## Comment Letter 1 – Rincon Band of Luiseño Indians

**Re: SCBP Buildings 1 & 2 Project**

## Response to Comment Letter 1 – Rincon Band of Luiseño Indians

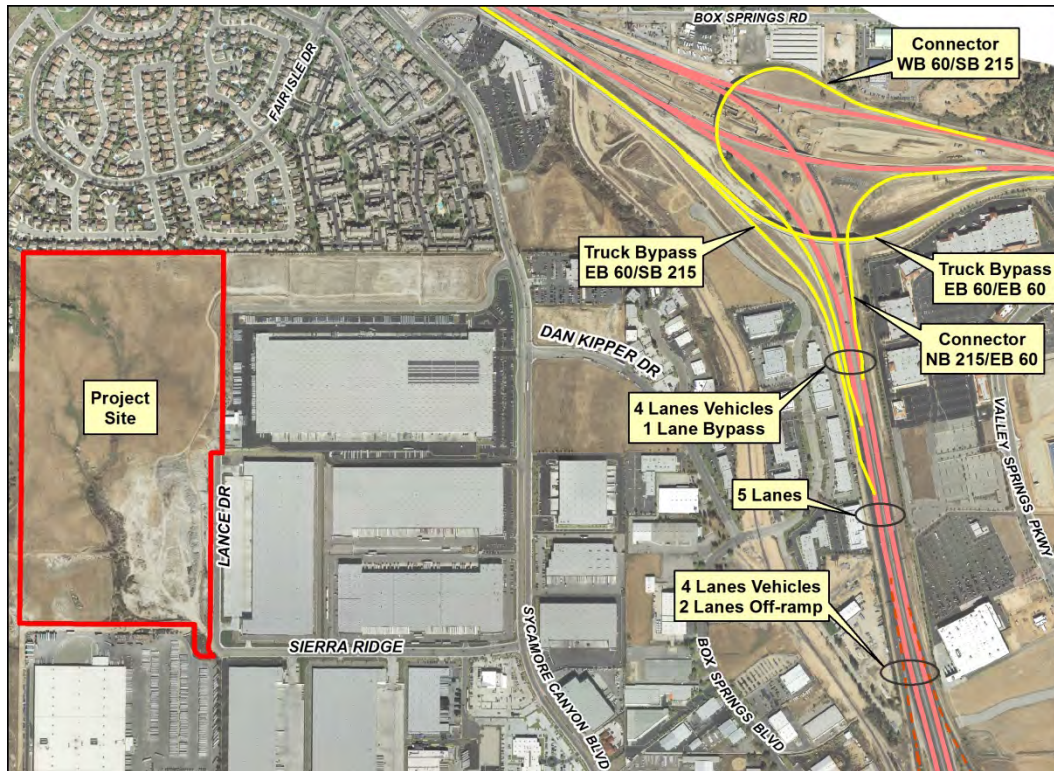
- Page (30) under "Project Trip Distribution" Figure 4-A depicts directional distribution traffic (PCE - Outbound) from the project. The figure shows that 100% cars /trucks will use Sierra Ridge Drive. Please explain how and what method of traffic control this project will use to stop cars/trucks from using Dan Kipper Drive for outbound traffic. Figure 4-B shows 20% of inbound traffic using Dan Kipper to the project. 8-P

Building 1 will have two driveways along Lance Drive and Building 2 will have one driveway along Lance Drive. Building 1 and Building 2 will have full ingress and right-out only egress at each of their individual project driveways. (DEIR, pp. 5.16-26.)

The Project will not allow passenger car and truck egress onto Dan Kipper Drive by installing small barriers (referred to as “pork chops”) at all three Project driveways that will limit left-out turns onto Lance Drive. (DEIR pp. 5.16-26.) This will force both outbound (i.e. leaving the Project site) passenger cars and trucks to turn south onto Lance Drive to Sierra Ridge Drive and then east on Sierra Ridge Drive to Sycamore Canyon Boulevard (see **DEIR Figure 5.16-3 – Project Trip Distribution (Passenger Cars – Outbound)**, and **DEIR Figure 5.16-5 Project Trip Distribution (Trucks – Outbound)**). From the intersection of Sierra Ridge Drive and Sycamore Canyon Boulevard, outbound vehicles will either turn north or south to travel to I-215 or other surrounding roadways. (DEIR, pp. 5.16-26.) This comment does not identify any significant new environmental issues or impacts that were not already addressed in the DEIR.
